LAWRENCE B. KARP
CONSULTING GEOTECHNICAL ENGINEER

Subject: 115 Telegraph Hill Boulevard, San Francisco
Planning Case No. 2013.1375CE [Block 0105 - Lot 065]
Appeal of [Project] Exemption from Environmental Review

COTTON, SHIRES AND ASSOCIATES, INC.
CONSULTING ENGINEERS AND GEOLOGISTS

SUBJECT: Preliminary Geologic and Geotechnical Review Comments
RE: 115 Telegraph Hill Boulevard
San Francisco, California

Photographs taken
by Lawrence B. Karp
at 240 Lombard SF
January 27, 2012

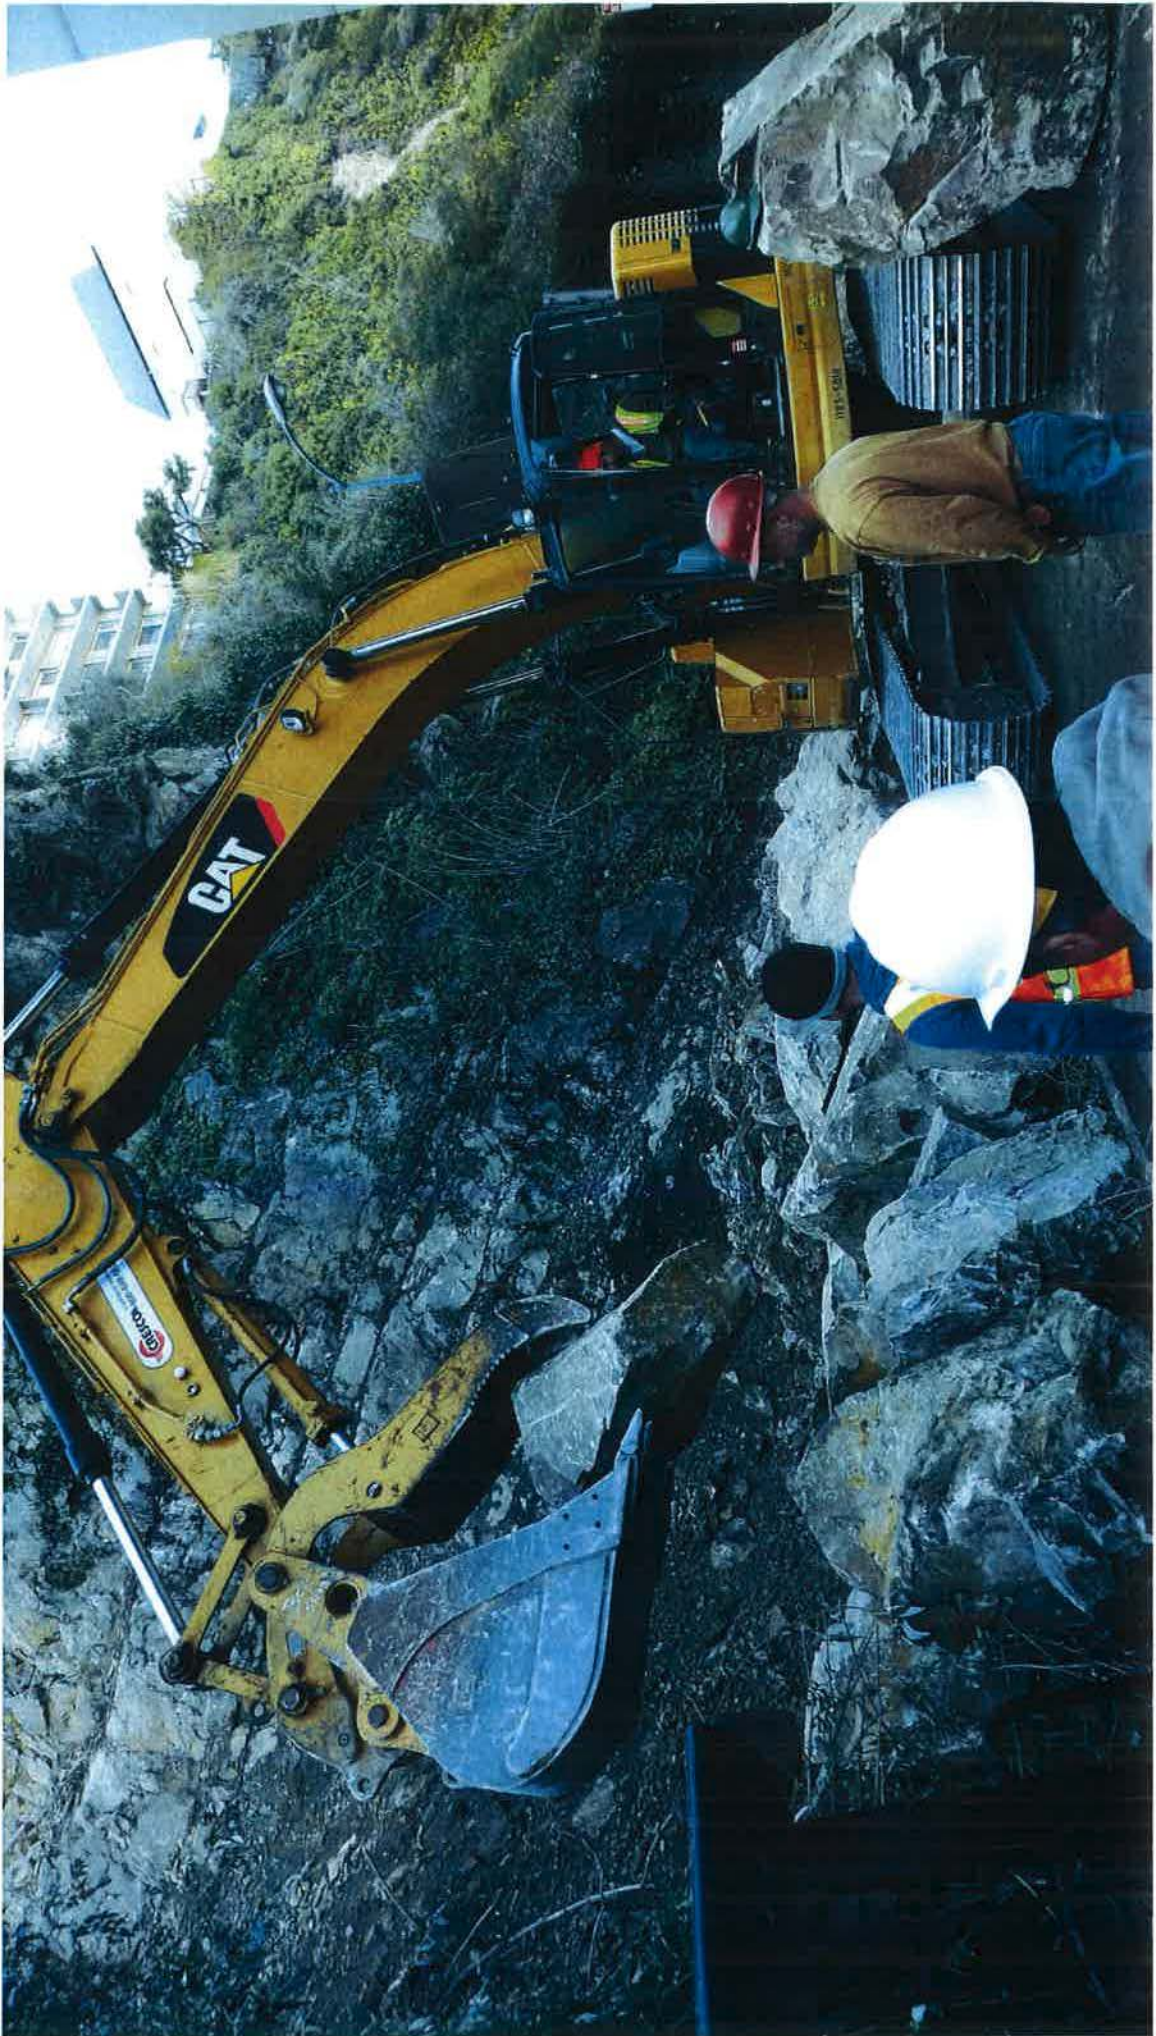
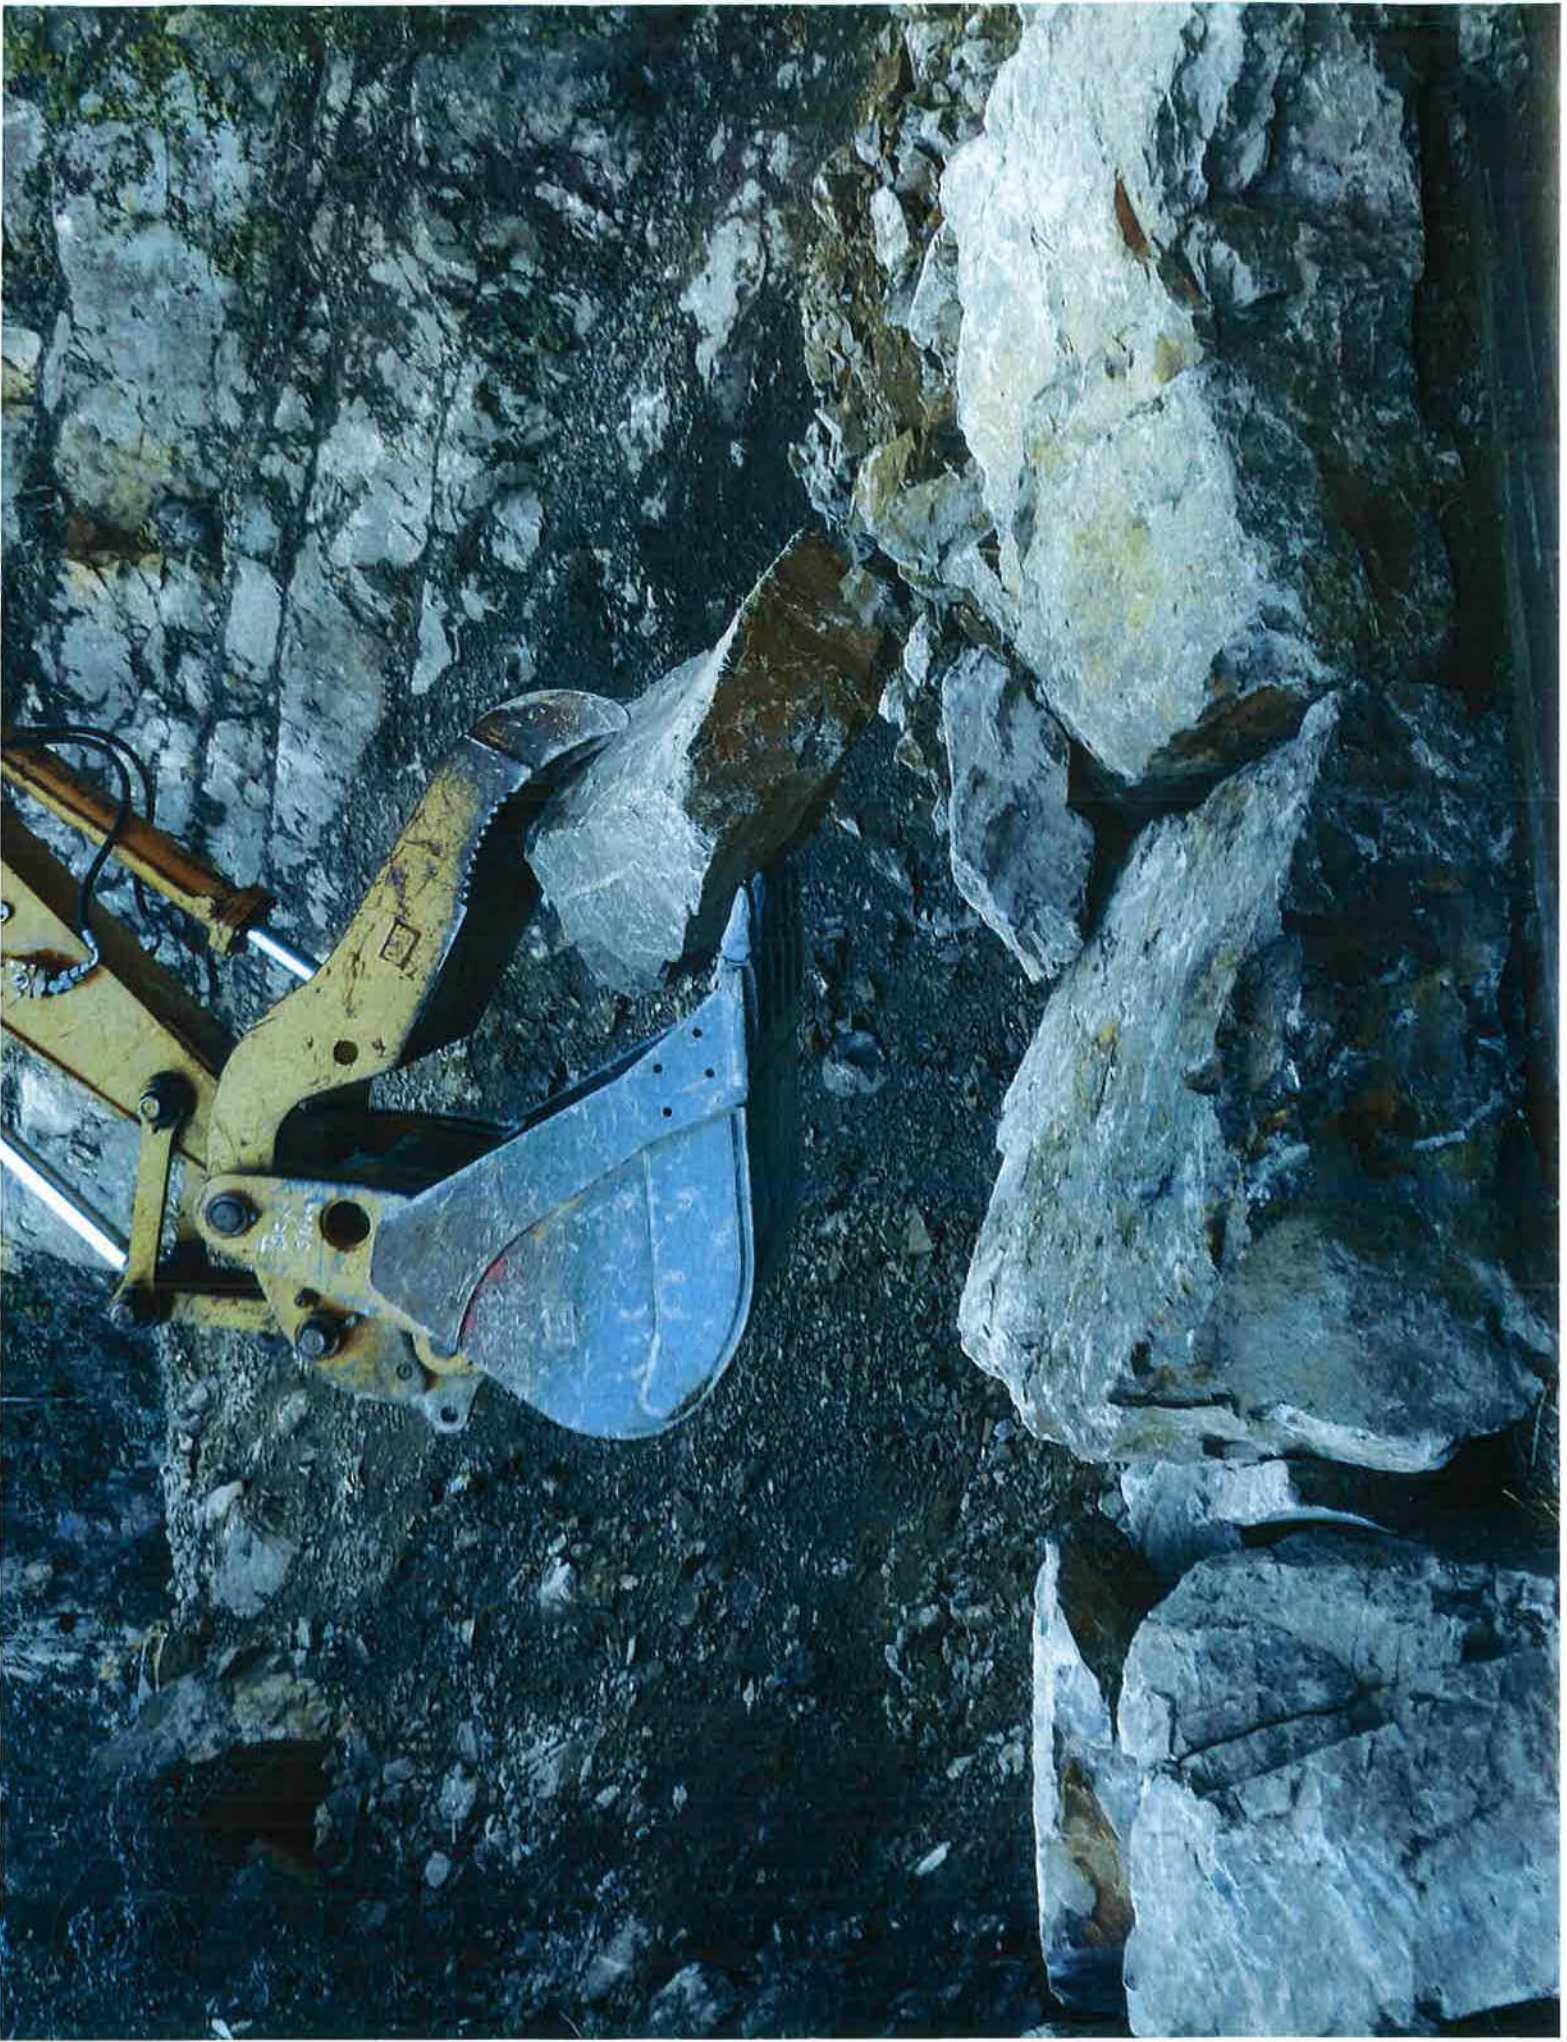
Dr. Karp, on Page 2 and 3, opines on the rockfall history of Telegraph Hill. In particular he states that the 2012 rockslide on the northeast side of Telegraph Hill failed in response to the erosion of shale interbeds.

CSA Response – CSA performed a detailed investigation of this failure, and the failure mechanism stated by Dr. Karp is not correct. **Our investigation report, on file with the City of San Francisco (Geologic and Geotechnical Investigation, Winthrop at Lombard Street Rockslope, prepared by Cotton, Shires and Associates, Inc., dated May 2014) documents the site conditions and causes/mechanisms of failure and they do not involve shale interbeds.**
